To: Members of the City Planning Commission  
From: Robert Dobruskin RD  
Date: September 1, 2017  
Re: **NYU Core – 181 Mercer Street Modification**  
CEQR No. 11DCP121M  
ULURP No. M 120124(A) ZSM  
SEQRA Classification: Type I

**TECHNICAL MEMORANDUM 003**  
**NYU CORE**  
**CEQR No. 11DCP121M**  
**ULURP No. C 120124 ZSM**

E-W Section through 181 Mercer Street  
Building Element C  
View North  
**Figure 6**

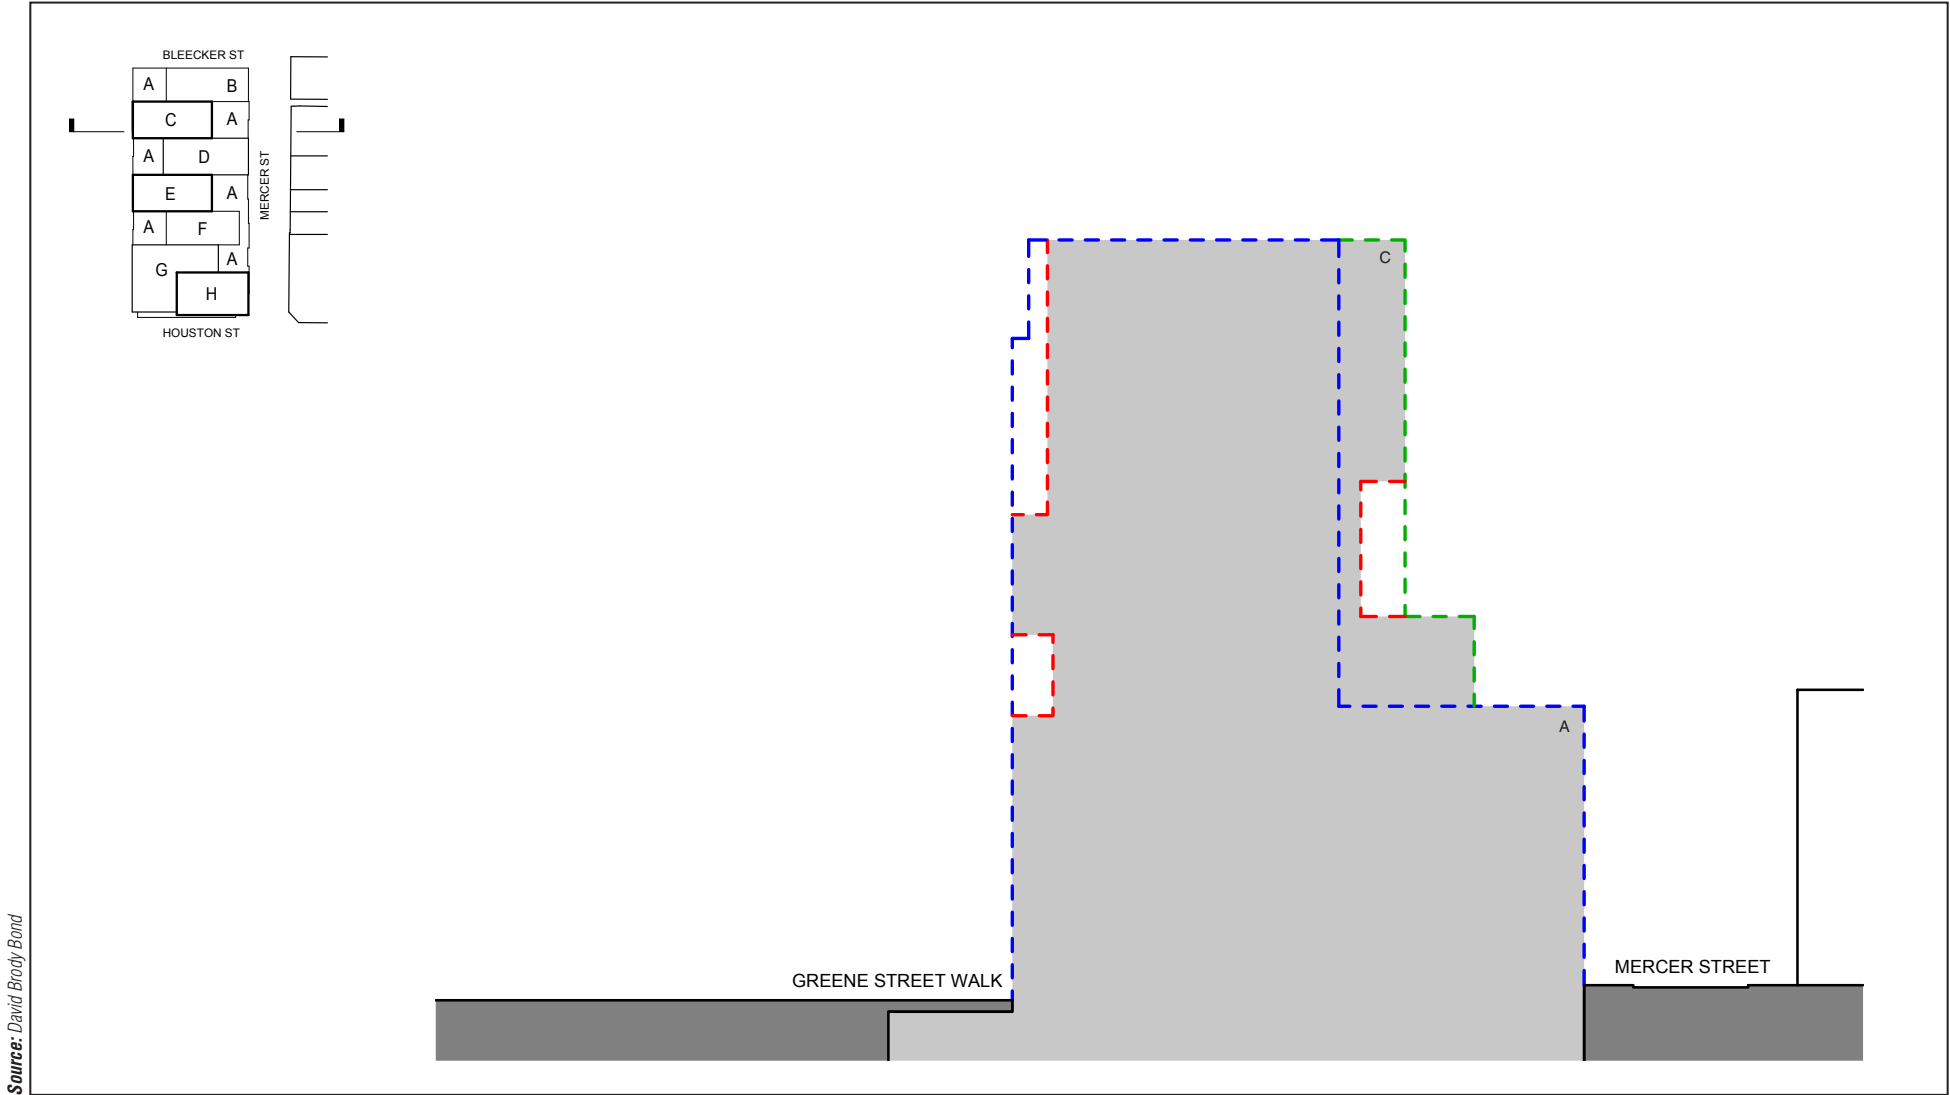
The Proposed Modification would adjust the maximum permitted building envelope for the 181 Mercer Street Building’s “C” tower as follows (illustrated in **Figure 6**):

- Elimination of the small setback (as shown in the Special Permit drawing Z- 122) at the bulkhead level of the western façade.

The “C” tower modification would shift the maximum envelope of the bulkhead westward to meet the maximum envelope of the tower below the bulkhead level. The articulation of the western façade of the “C” tower would be implemented through a new larger setback from Greene Street Walk above the plinth. At some elevations, the new setback above the plinth would apply to the entire “C” tower frontage on Greene Street Walk; at other elevations, the new setback would apply to only a portion of the “C” tower. The new pattern of setbacks is illustrated in **Figure 5**. The new setbacks would reduce the mass of the portion of the “C” tower facing Greene Street Walk above the 85-foot plinth level to a greater extent than the setback in the Special Permit drawings approved in 2012.

NYU and its architects have determined that the proposed elimination of the bulkhead setback would enable a unified approach to the setbacks and façade articulation on the “C” tower and that an additional setback at the bulkhead level would detract from the façade design. This modification would not increase the maximum permitted floor area for the 181 Mercer Street Building.

E-W Section through 181 Mercer Street  
 Building Element E  
 View North  
**Figure 7**

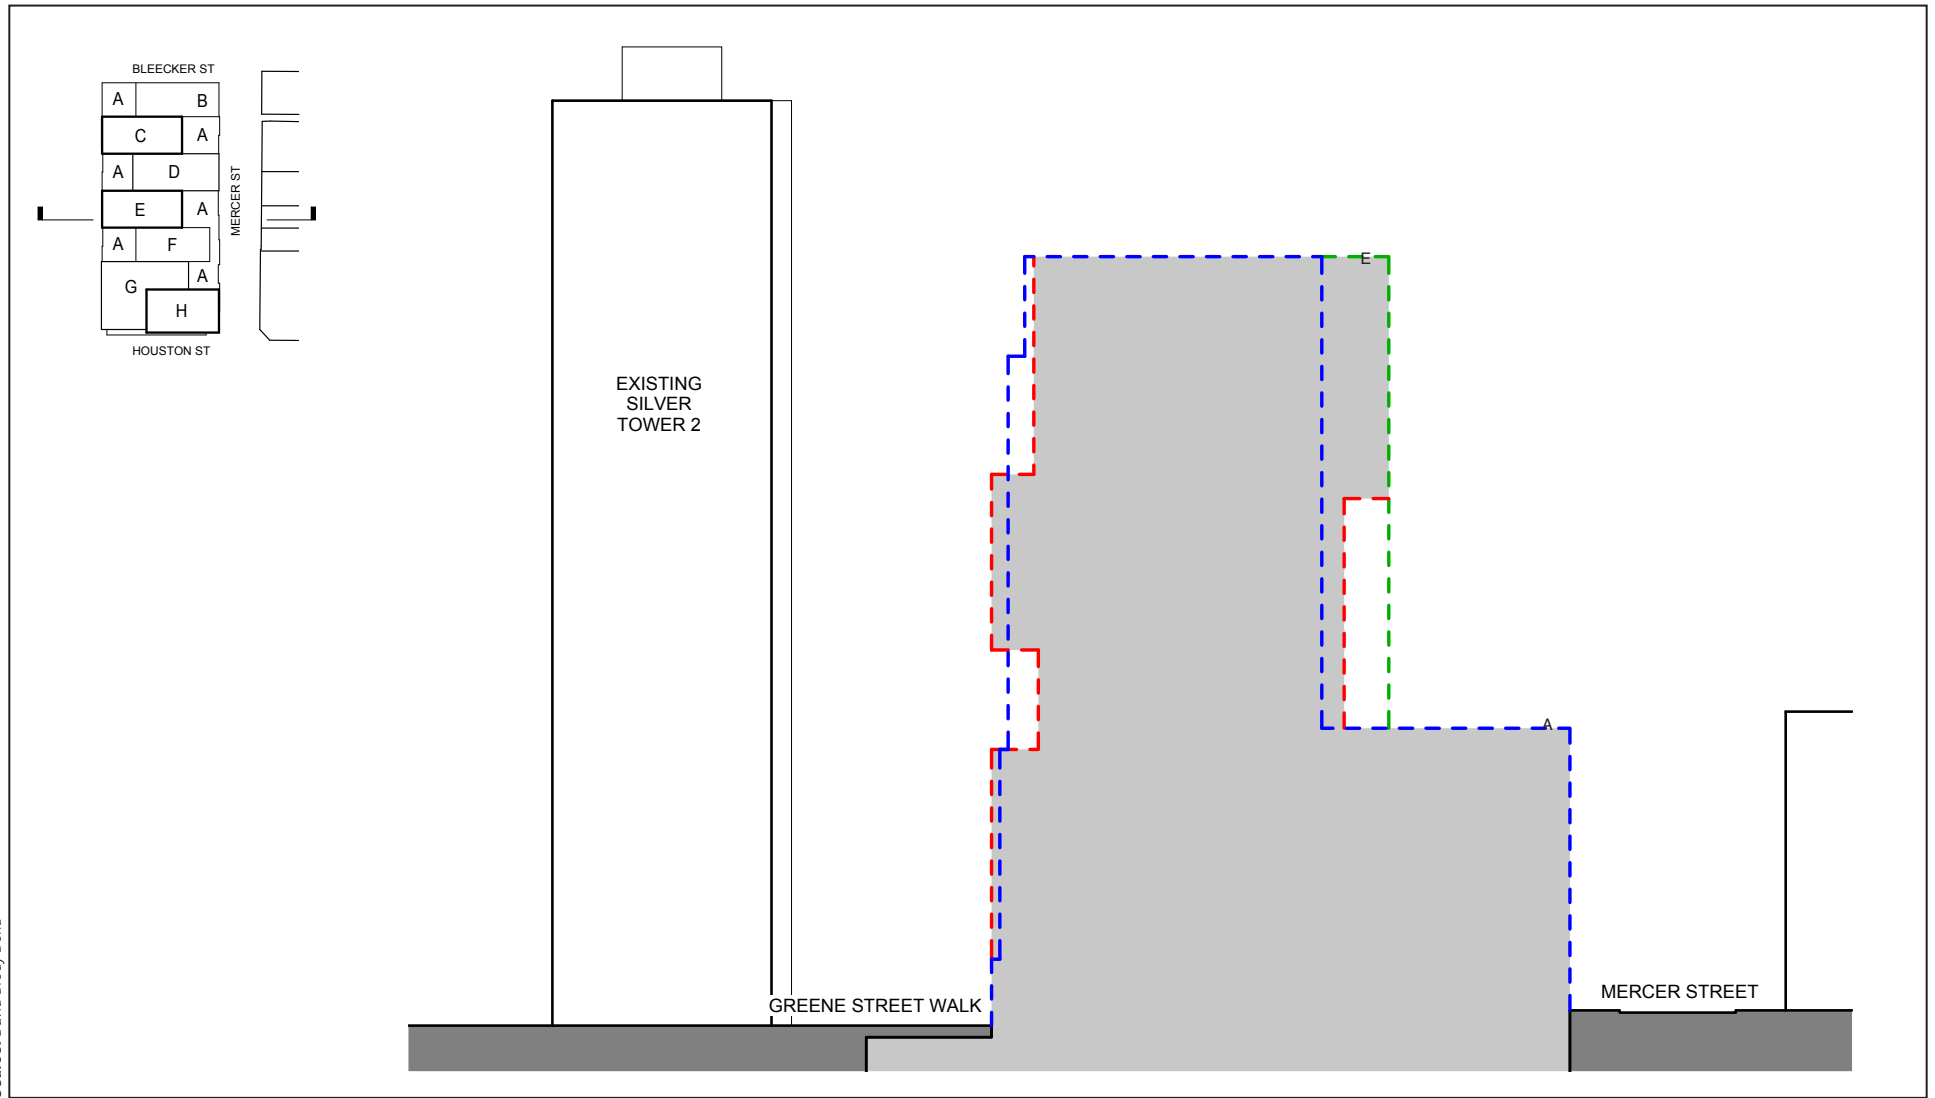
The maximum permitted envelope for the 181 Mercer Street Building’s “E” tower would be adjusted as follows (see **Figure 7**):

- Elimination of the small setback (as shown in the Special Permit drawing Z-122) of the western façade at the top of the first floor.
- Elimination of the small setback (as shown in the Special Permit drawing Z-122) of the western façade at the plinth level.
- Elimination of the small setback (as shown in the Special Permit drawing Z-122) of the western façade at the bulkhead level.

The “E” tower modification would shift the maximum permitted envelope (above the first level of the tower) westward to meet the maximum envelope at the first level of the tower. Similar to the modification described above for the “C” tower, the articulation of the western façade of the “E” tower would be implemented through a new larger setback from Greene Street Walk above the plinth. At some elevations, the new setback above the plinth would apply to the entire “E” tower frontage on Greene Street Walk; at other elevations, the new setback would apply to only a portion of the “E” tower. The new pattern of setbacks is illustrated in **Figure 5**. The new setbacks would reduce the mass of the portion of the “E” tower facing Greene Street Walk above the 85-foot plinth level to a greater extent than the setback in the Special Permit drawings approved in 2012.

Similar to the “C” tower, NYU and its architects have determined that the proposed elimination of the Special Permit-required setbacks on the “E” tower would allow for a unified approach to the setbacks and façade articulation on the “E” tower and that the Special Permit setbacks would detract from the façade design. The façade articulation on the “C” and “E” towers would be consistent. This modification would not increase the maximum permitted floor area for the 181 Mercer Street Building.

E-W Section through 181 Mercer Street  
 Building Element G  
 View North  
**Figure 8**

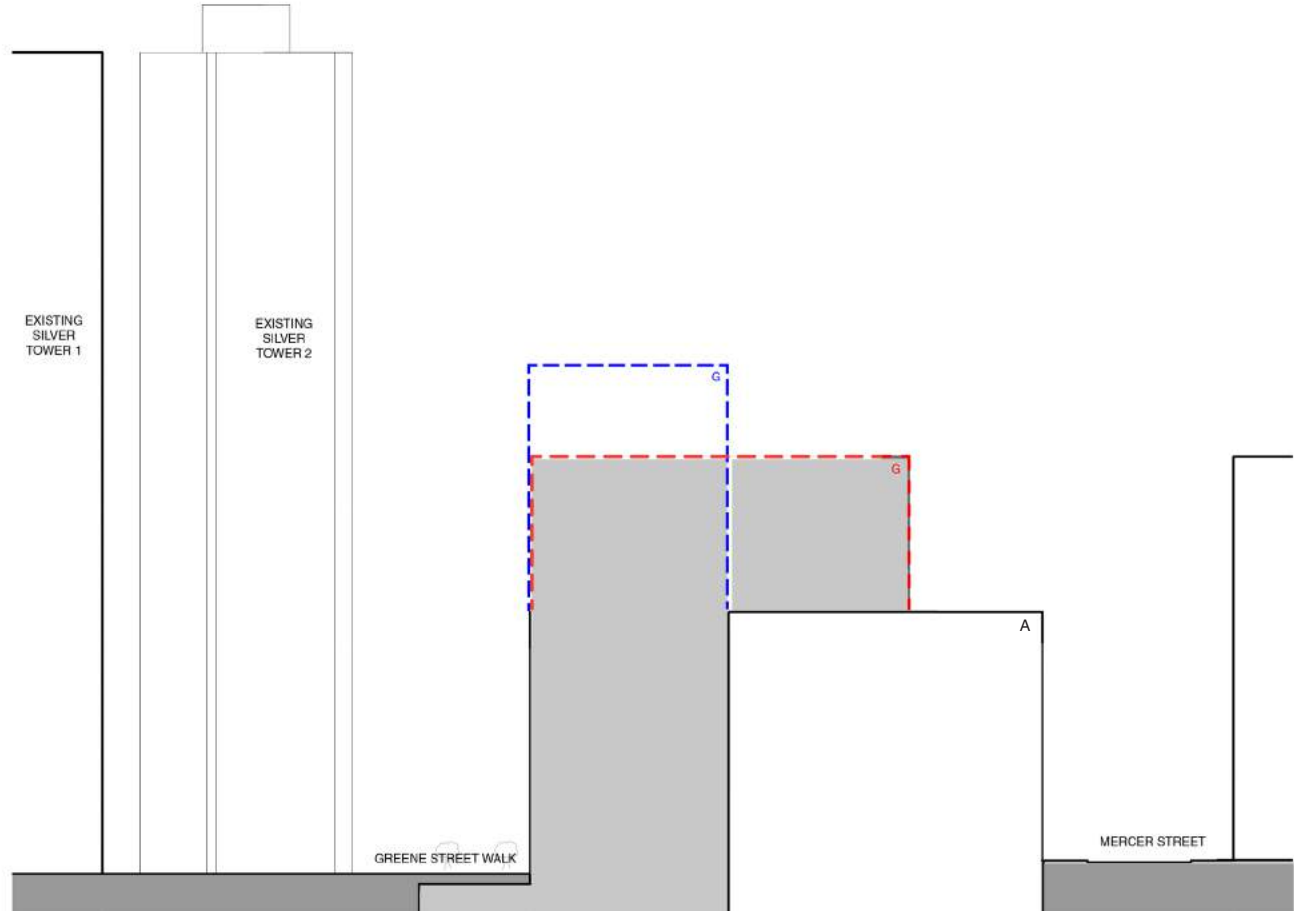
The Proposed Modification would adjust the maximum permitted building envelope for the 181 Mercer Street Building’s “G” tower as follows (illustrated in **Figures 8, 9, and 10**):

- A reduction in the height of the “G” tower from 168 feet (the maximum height specified in the Special Permit drawing Z-102) to 138 feet.
- An extension of the width of the “G” tower in the east-west direction beyond the 67.5 feet specified in Special Permit drawing Z-102, reducing the east-west length of the plinth between the “H” and “F” towers to less than the 107 feet specified in the same drawing.

The result of the above-described modification would be a shift in the bulk of the “G” tower to a lower elevation located over the rear portion of the “A” plinth between the “H” and “F” towers of the building (see **Figure 10**). The shifted bulk of the “G” tower over the rear portion of the “A” plinth would be compliant with the height and setback regulations of the underlying zoning district and the Design Guidelines for the building specified in Special Permit drawing Z-122. The shifted bulk would not require any waivers. Although important to the 181 Mercer Street Building’s functionality (as discussed below), the shifted bulk would be an immaterial change to its massing, accounting for less than 1 percent of the cubic volume of the building allowed by the Special Permit.

While the “G” tower could be constructed in compliance with existing Special Permit approvals, the Proposed Modification would allow NYU to maximize the functionality of the 181 Mercer Street Building. With the Proposed Modification, the first level of the shifted bulk—at the sixth floor of the building—would contain critical circulation space connecting the “F” and “G” towers at this level, which is the level of the orchestra rehearsal room in the “F” tower and the level of the orchestra-related lobby, bathrooms, and instrumental music instructional space in the “G” tower. This first level of the shifted bulk would also contain instructional space for the instrumental music program and orchestra rehearsal storage. The second level of the shifted bulk at the rear portion of the “A” plinth would accommodate air handlers and other mechanical space that—due to the very large size of the equipment—would extend at this level into adjoining portions of the adjacent “H” and “G” towers. These air handlers provide air circulation to the southern portion of the building’s plinth and would function better at this location than the

Roof Plan Comparison  
Figure 10

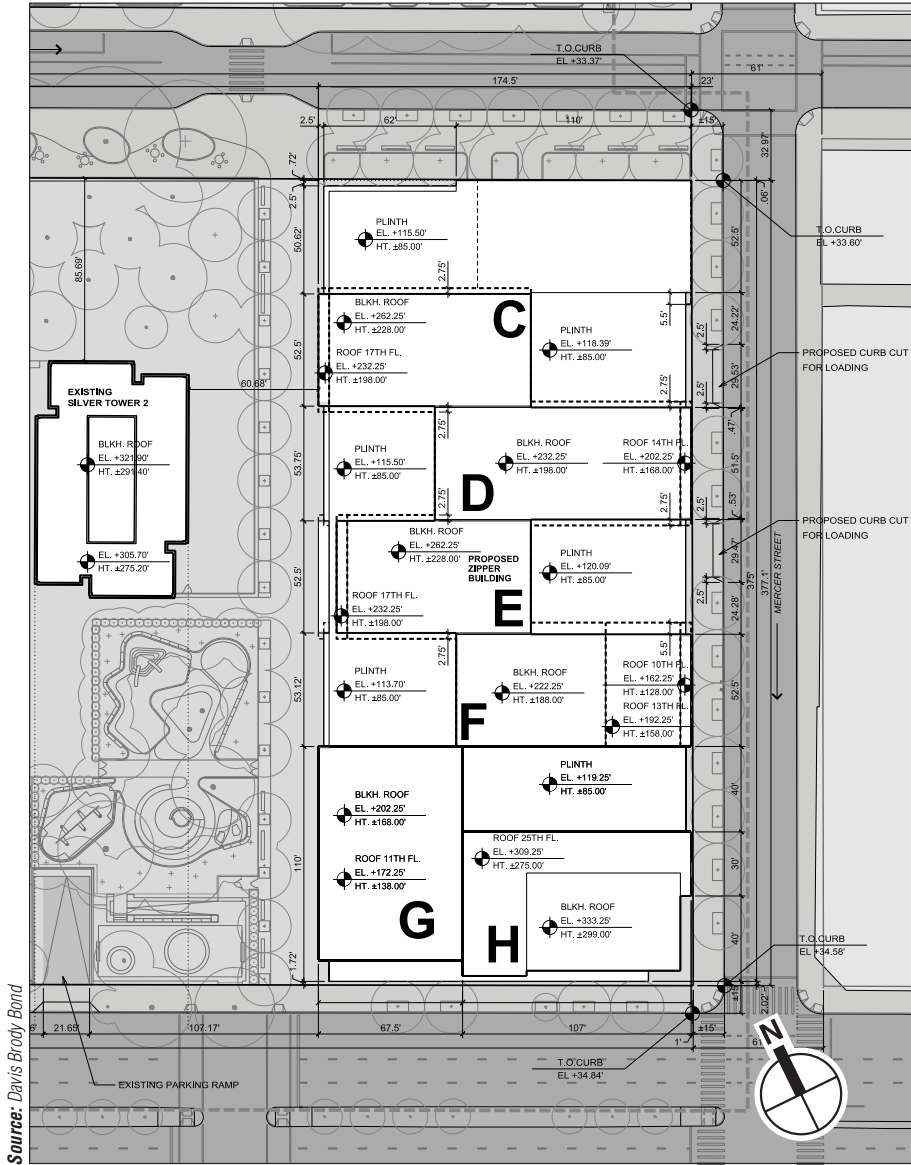
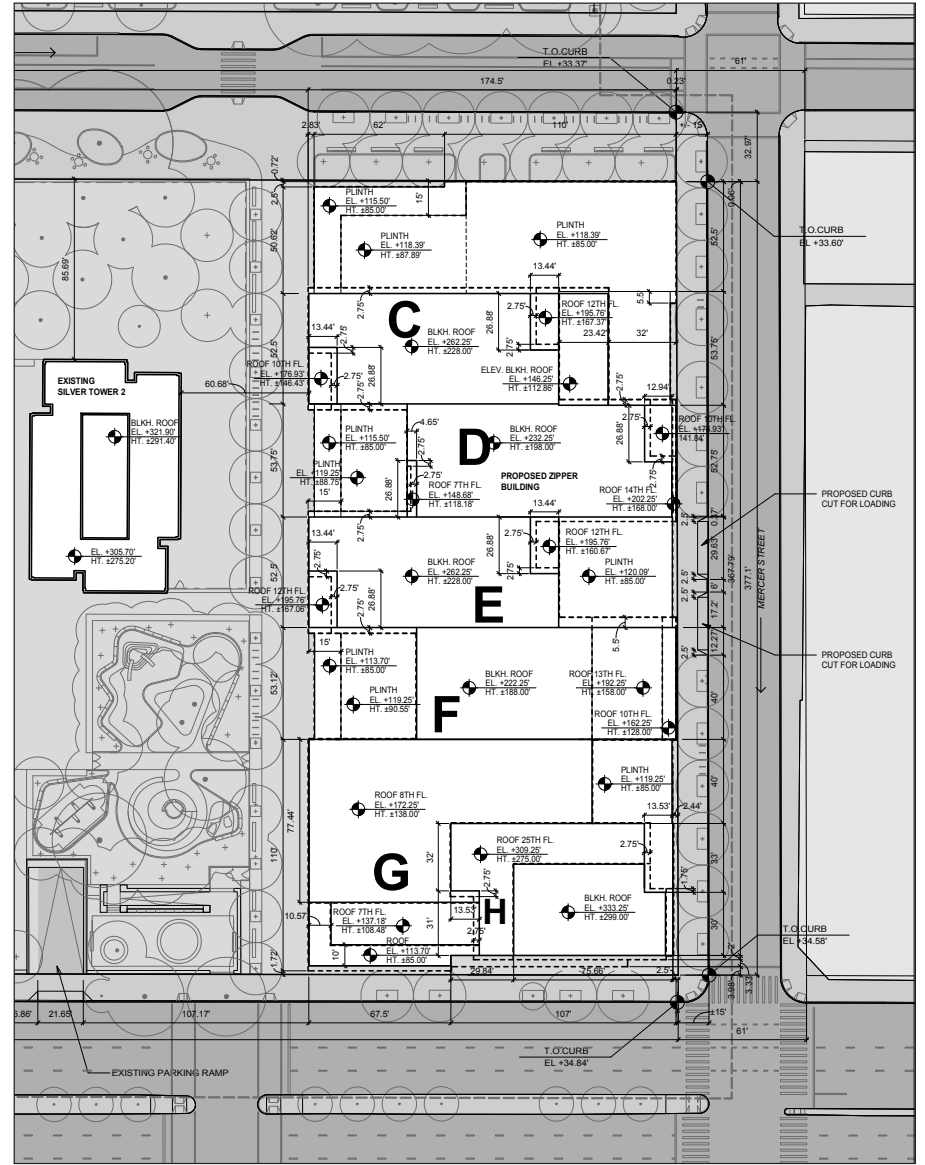
roof of the “G” tower, where they would be at a greater distance from the portion of the building they would serve. Without the Proposed Modification, the air handlers would be located on the roof of the “G” tower and would block windows of the faculty apartments on the western façade of the “H” tower and add to the building’s bulk as perceived from the adjacent University Village and other vantage points west of the building.

The maximum permitted envelope for the 181 Mercer Street Building’s “H” tower would be adjusted as follows (see **Figures 10 and 11**):
